Agenda
City of Springboro Planning Commission Meeting
Wednesday, July 10, 2024, 6:00 p.m.
Council Chambers, City Building, 320 West Central Avenue

Background Information & Staff Recommendations
City of Springboro Planning Commission Meeting
Wednesday, July 10, 2024, 6:00 p.m.
Council Chambers, City Building, 320 West Central Avenue

OVERALL SITE PLAN

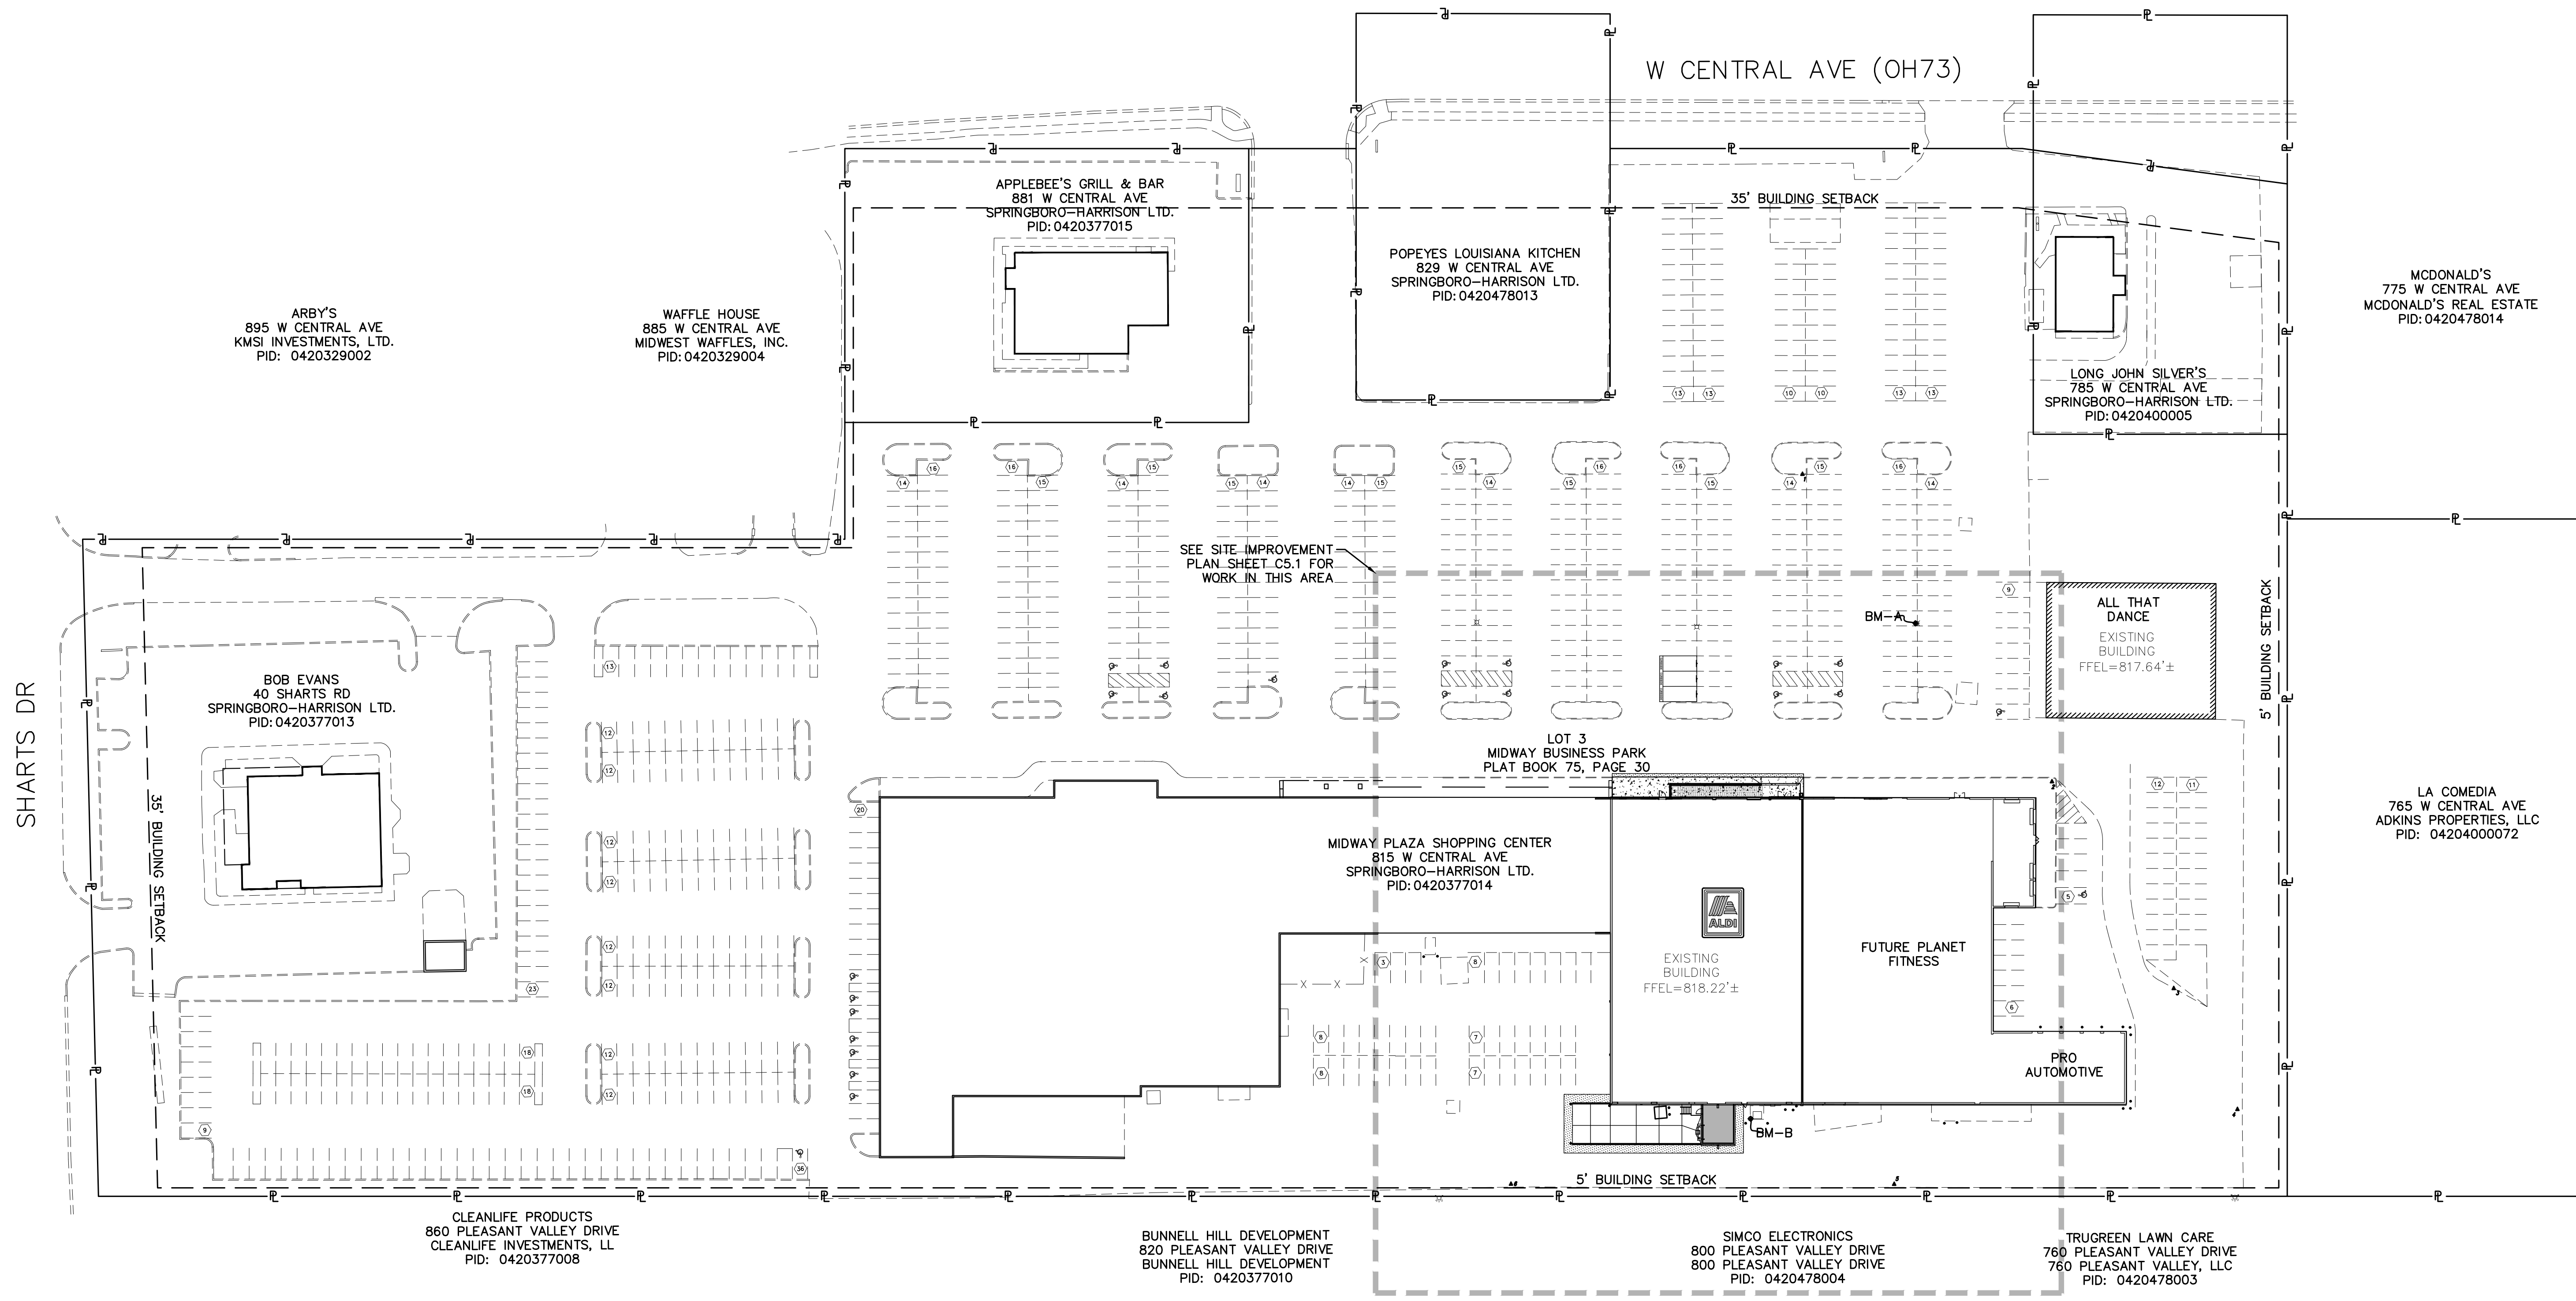
8. Overall site plan Sheet C5.0 has the property line for Popeyes shown incorrectly. The right-of-way has been previously dedicated along West Central Avenue.

Proposed Rear Elevation

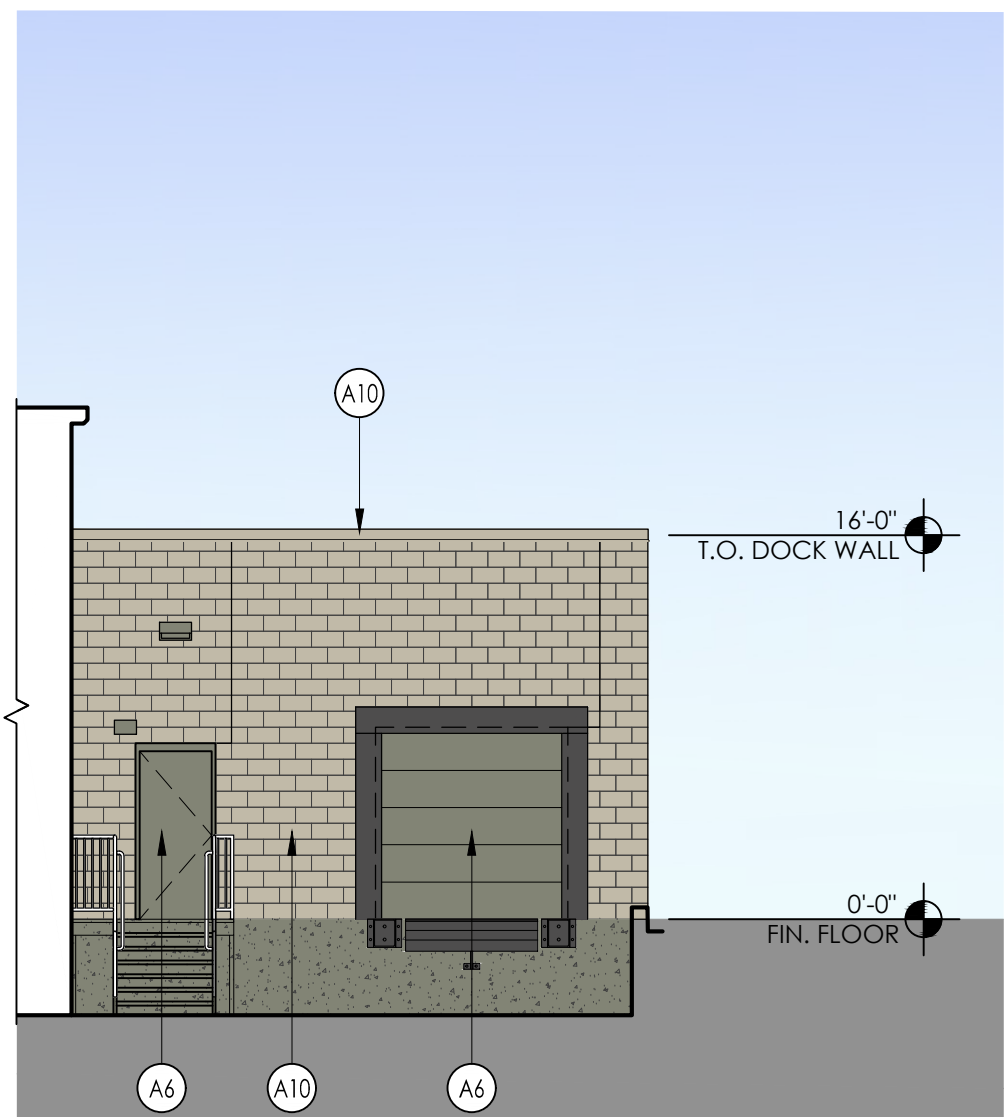
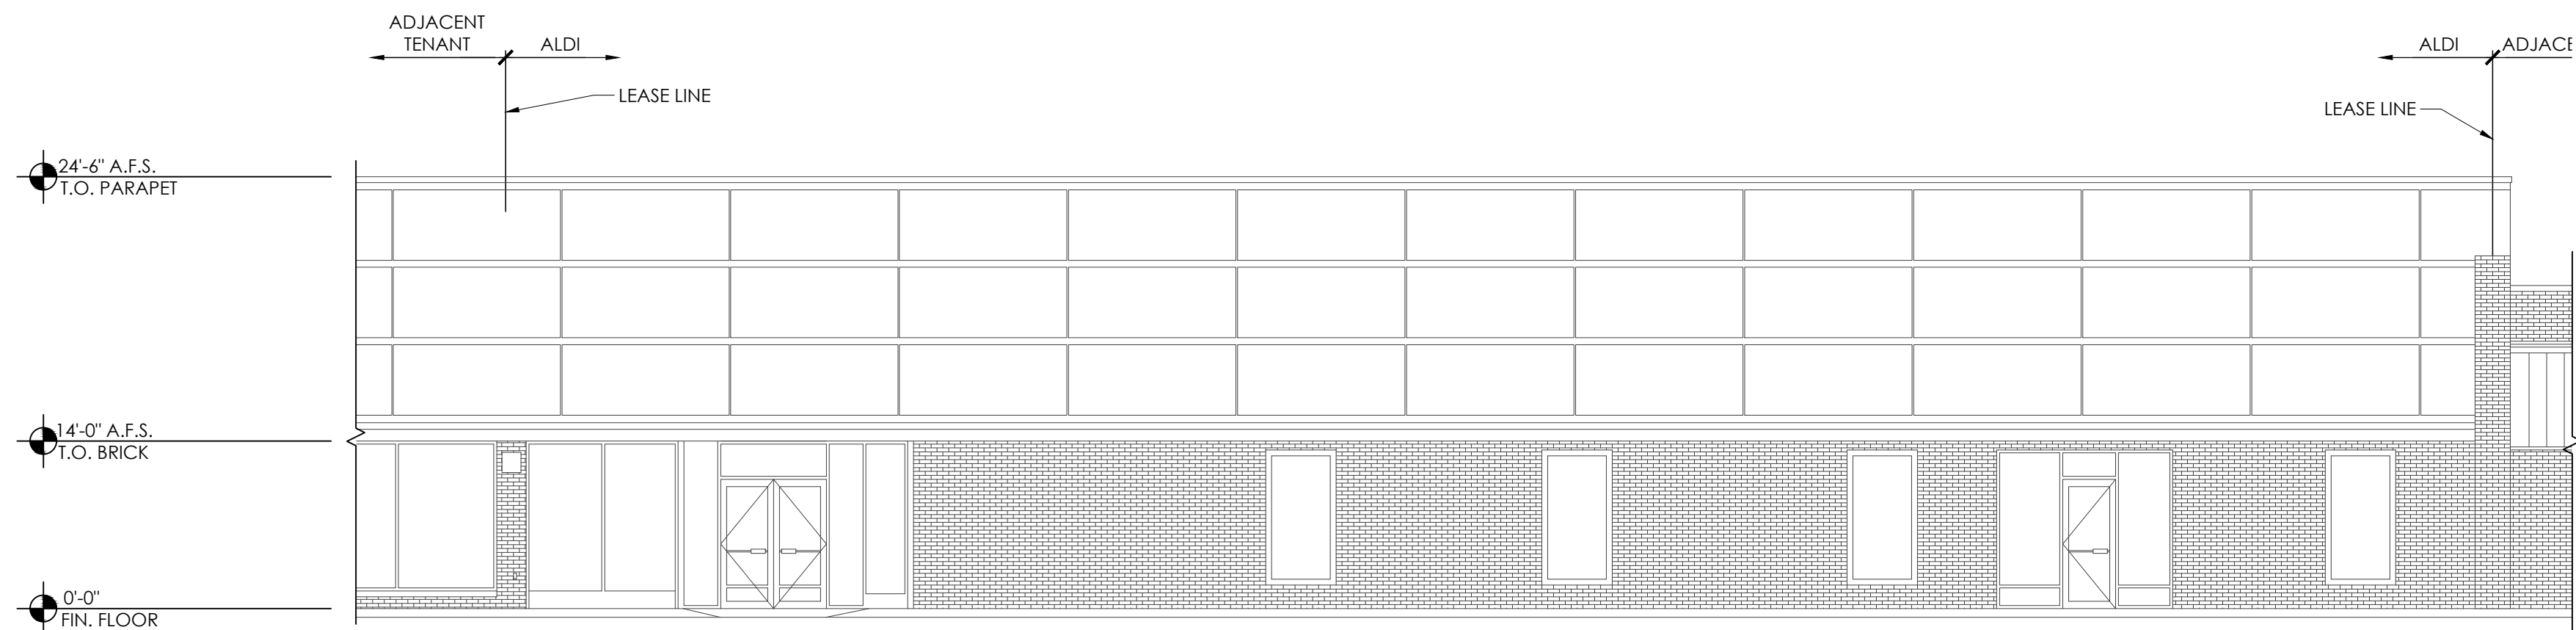
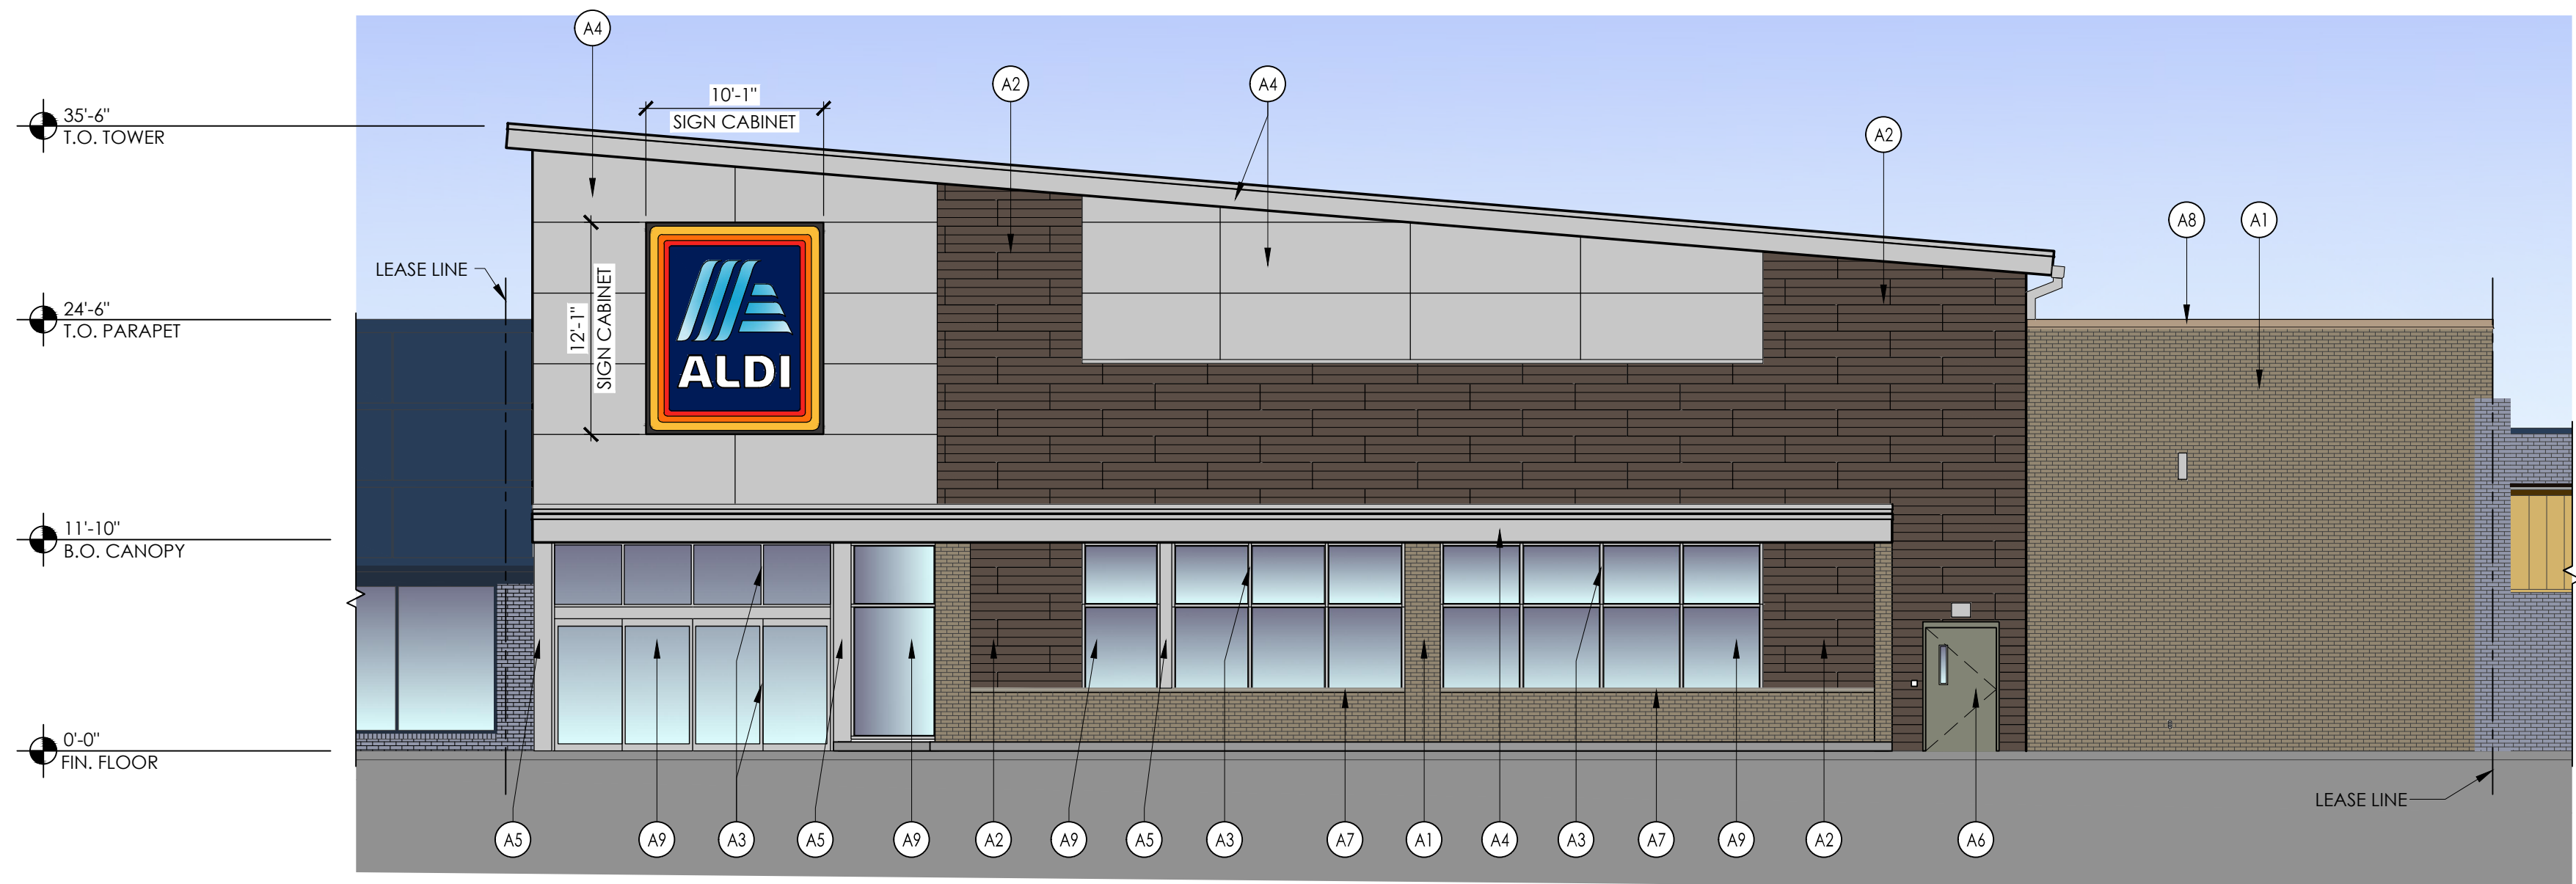
6. Add graphical scale to building elevation sheets. Also revise the elevation callouts to be north and south, not front and back.
7. Remove one existing rear parking stall that is adjacent to the proposed bollard at the south (back) of the property near loading dock.
